Re: Revision To Administrative Order No. WFX-679
Grayburg-Jackson Waterflood Project
Eddy County, NM

Please accept our request to amend Administrative Order No. WFX-679 to include the following wells:

DEVON ENERGY OPERATING CORPORATION
APPLICATION FOR AUTHORITY TO INJECT
GRAYBURG-JACKSON WATERFLOOD

H.E.WEST "B" #94

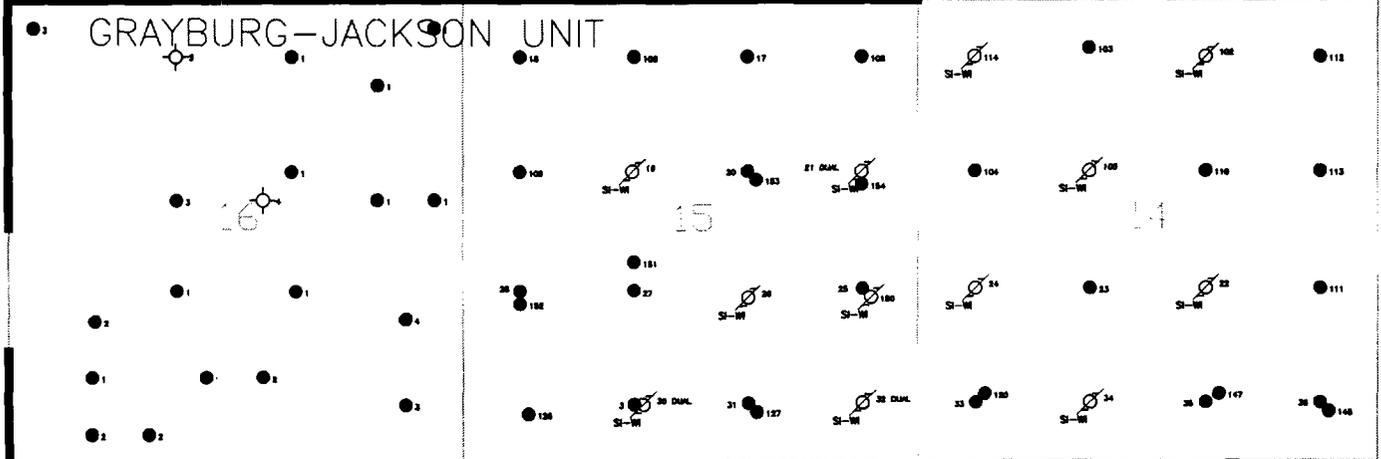
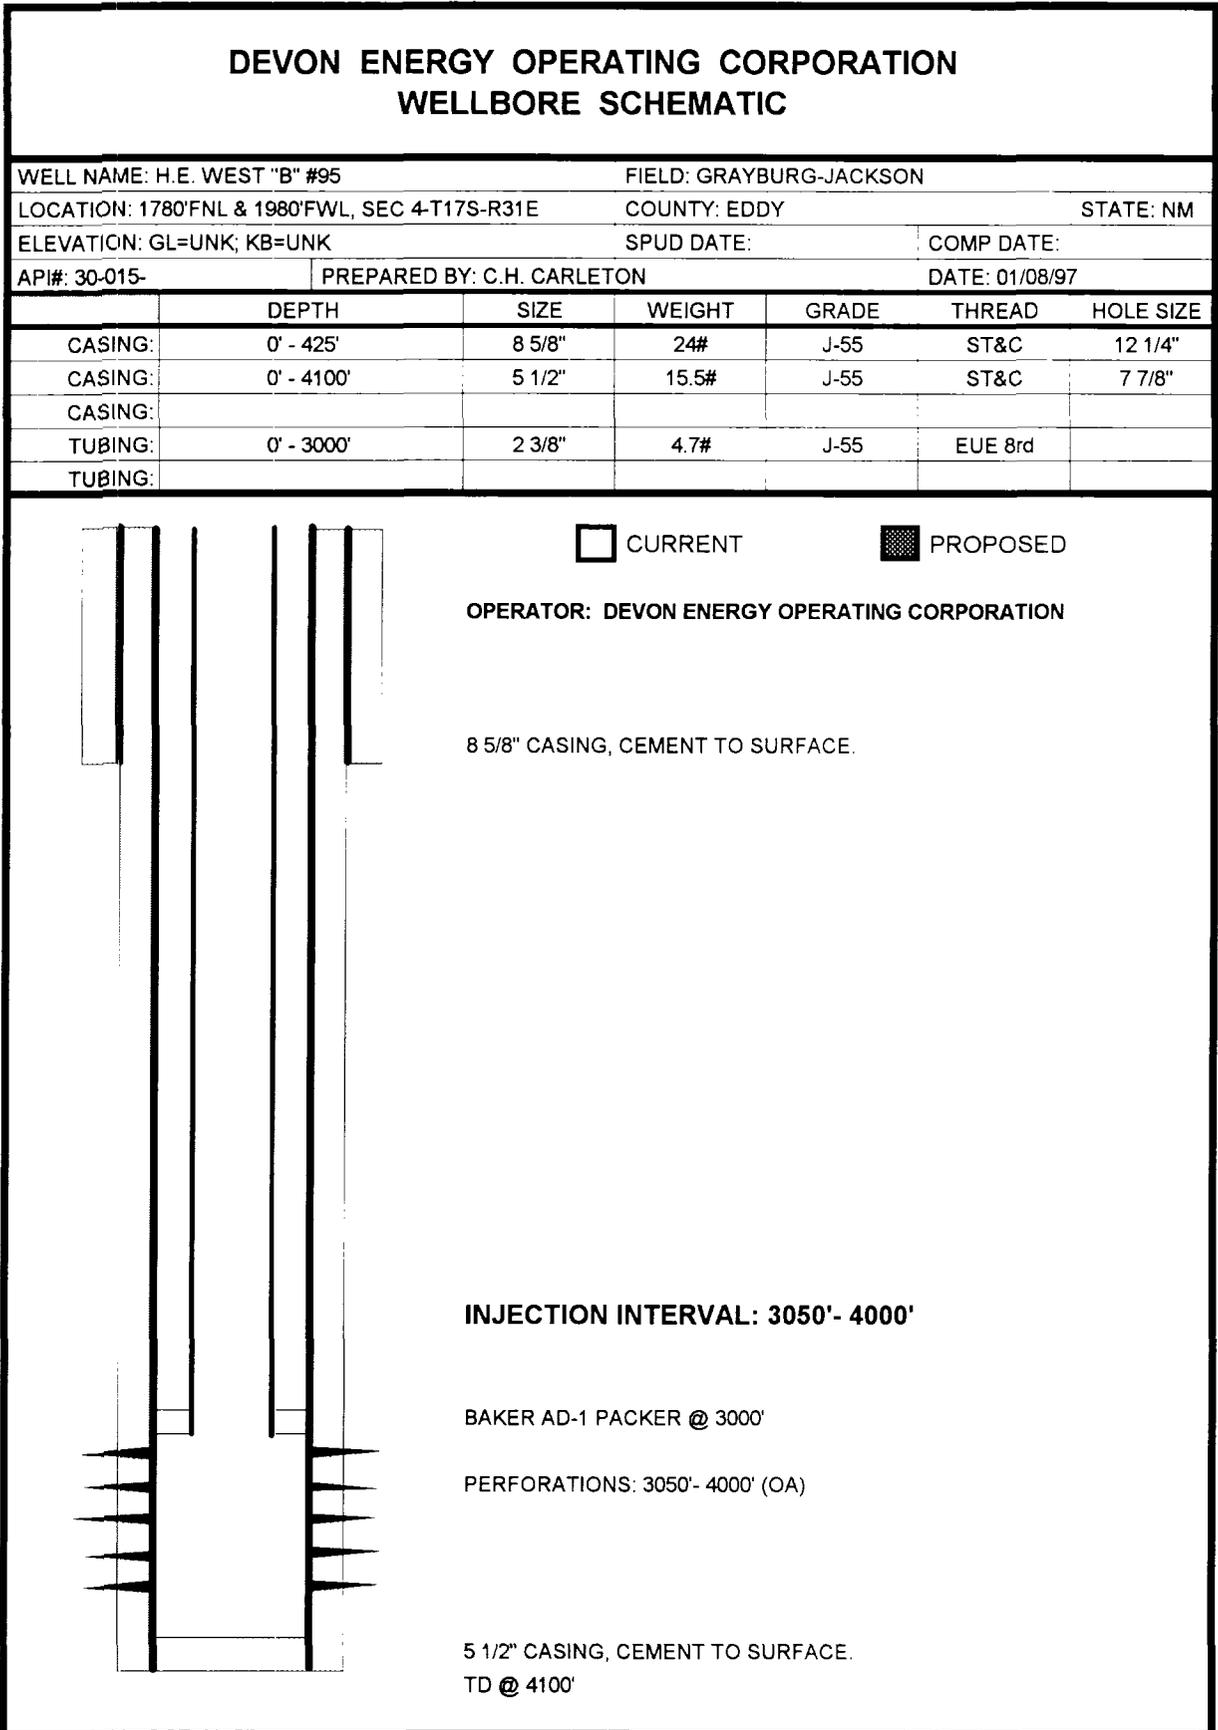
- A. (1) H.E. West "B" #94
440'FNL & 1980'FEL
Section 10-T17S-R31E
Eddy County, NM
- (2) Surface Casing:
8 5/8" 24# J-55 ST&C @ 425'. TOC @ surface
Hole Size = 12 1/4"
- Production Casing:
5 1/2" 15.5# J-55 LT&C @ 4250'. TOC @ surface
Hole Size = 7 7/8"
- (3) Tubing will be 2 3/8" 4.7# J-55 EUE 8rd (IPC) set at 3150'.
- (4) 5 1/2" Baker AD-1 tension packer set at 3150'.
- B. (1) The injection formation will be the Grayburg/San Andres in the Grayburg-Jackson Field.
- (2) Water injection will be through perforations 3200'- 4150'(OA). **The injection interval is 3200'- 4150'.**
- (3) This well will be drilled and completed as an injection well, injecting into the Grayburg/San Andres formation.
- (4) Additional perforations may be added in the 3200'- 4150' interval.
- (5) The top of the Seven Rivers formation is at approximately 2300', there are no known lower oil zones

H.E. WEST "B" #95

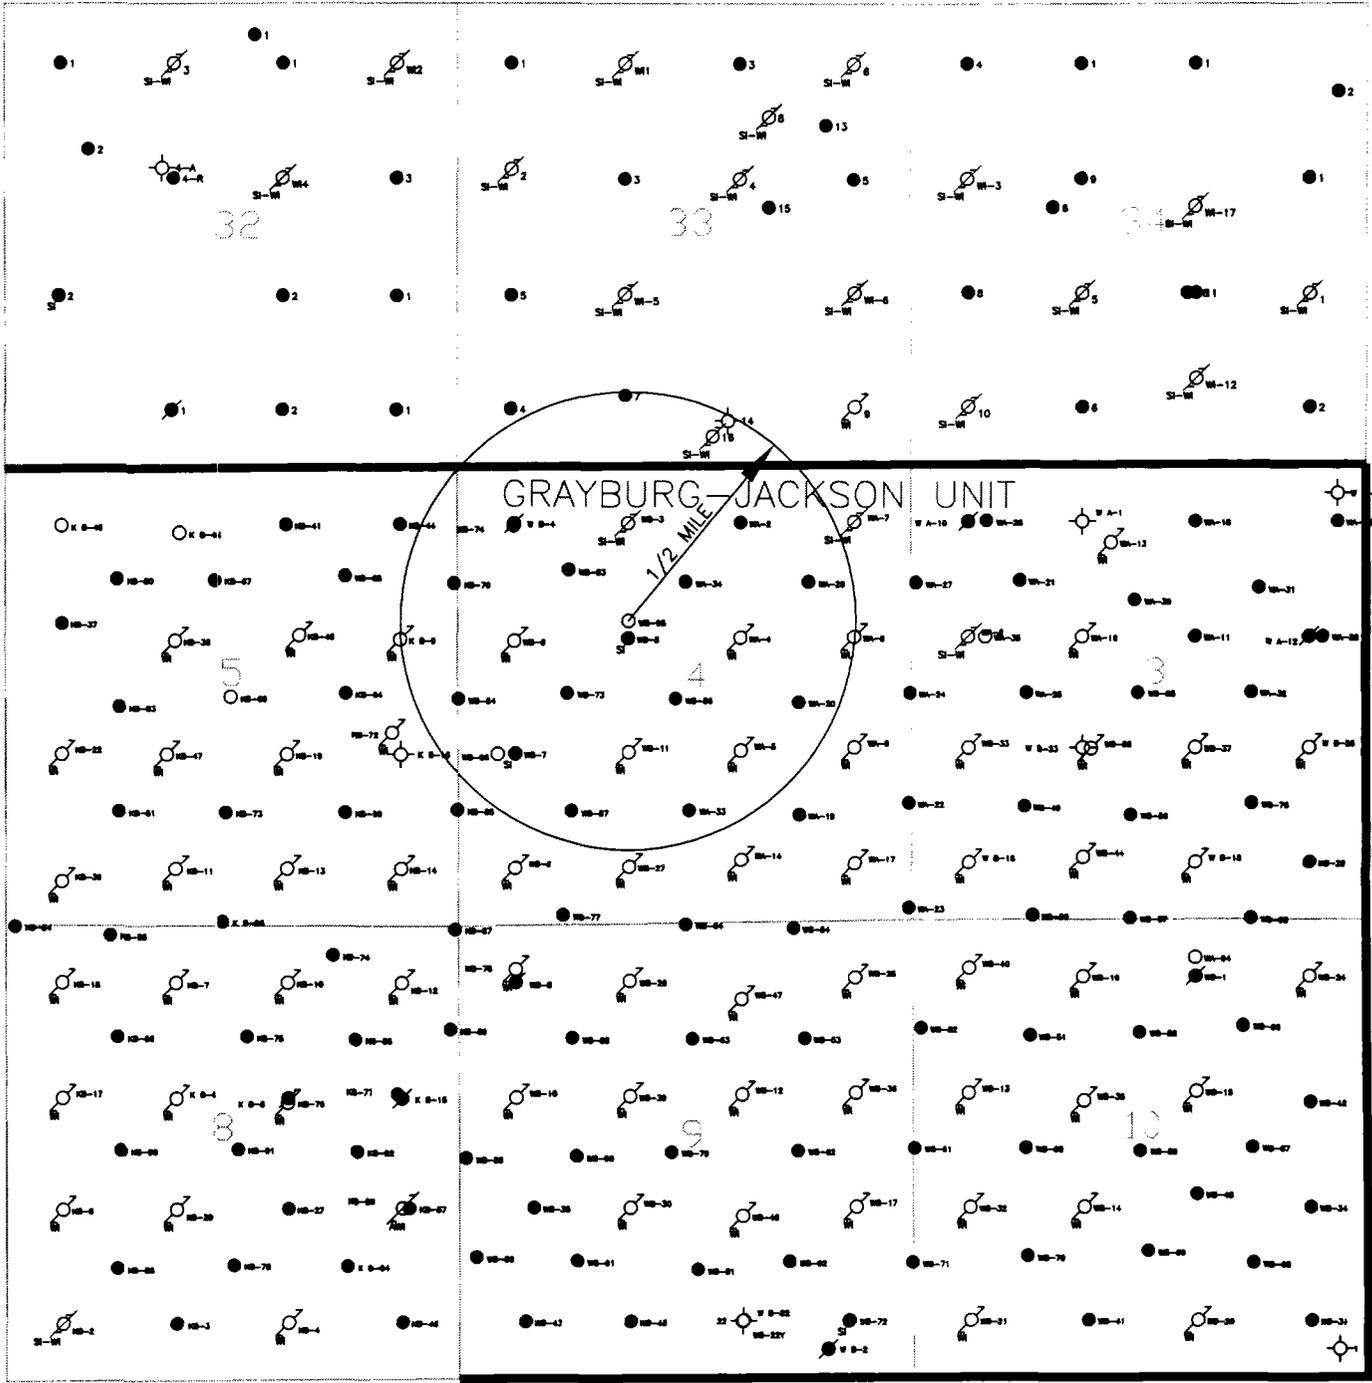
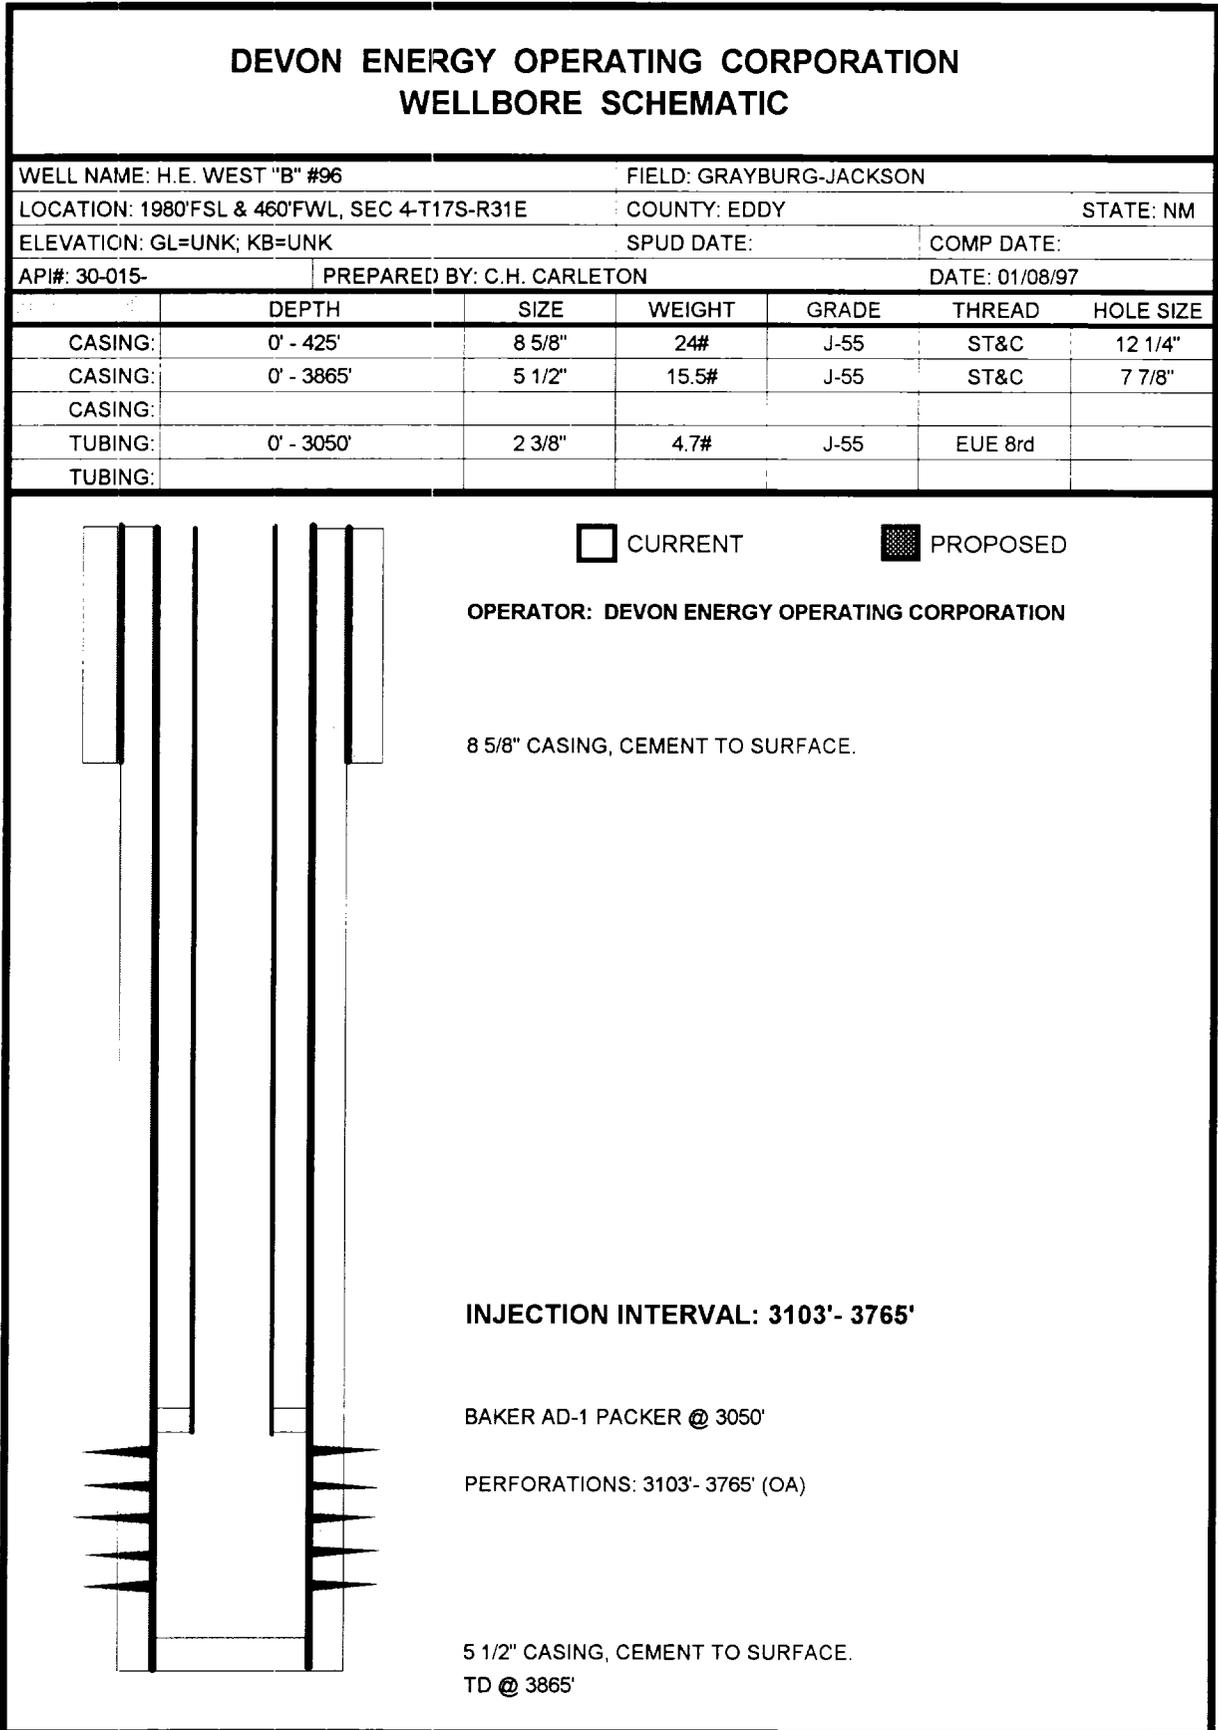
- A. (1) H.E. West "B" #95
1780'FNL & 1980'FWL
Section 4-T17S-R31E
Eddy County, NM
- (2) Surface Casing:
8 5/8" 24# J-55 ST&C @ 425'. TOC @ surface
Hole Size = 12 1/4"
- Production Casing:
5 1/2" 15.5# J-55 LT&C @ 4100'. TOC @ surface
Hole Size = 7 7/8"
- (3) Tubing will be 2 3/8" 4.7# J-55 EUE 8rd (IPC) set at 3000'.
- (4) 5 1/2" Baker AD-1 tension packer set at 3000'.
- B. (1) The injection formation will be the Grayburg/San Andres in the Grayburg-Jackson Field.
- (2) Water injection will be through perforations 3050'- 4000'(OA). **The injection interval is 3050'- 4000'.**
- (3) This well will be drilled and completed as an injection well, injecting into the Grayburg/San Andres formation.
- (4) Additional perforations may be added in the 3050'- 4000' interval.
- (5) The top of the Seven Rivers formation is at approximately 2300', there are no known lower oil zones

H.E. WEST "B" #96

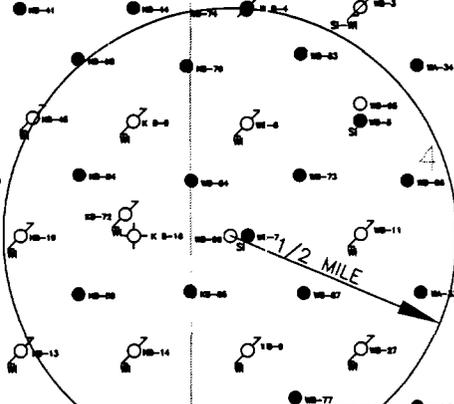
- A. (1) H.E. West "B" #96
1980'FSL & 460'FWL
Section 4-T17S-R31E
Eddy County, NM
- (2) Surface Casing:
8 5/8" 24# J-55 ST&C @ 425'. TOC @ surface
Hole Size = 12 1/4"
- Production Casing:
5 1/2" 15.5# J-55 LT&C @ 3865'. TOC @ surface
Hole Size = 7 7/8"
- (3) Tubing will be 2 3/8" 4.7# J-55 EUE 8rd (IPC) set at 3050'.
- (4) 5 1/2" Baker AD-1 tension packer set at 3050'.
- B. (1) The injection formation will be the Grayburg/San Andres in the Grayburg-Jackson Field.
- (2) Water injection will be through perforations 3103'- 3765'(OA). **The injection interval is 3103'- 3765'.**
- (3) This well will be drilled and completed as an injection well, injecting into the Grayburg/San Andres formation.
- (4) Additional perforations may be added in the 3103'- 3765' interval.
- (5) The top of the Seven Rivers formation is at approximately 2300', there are no known lower oil zones
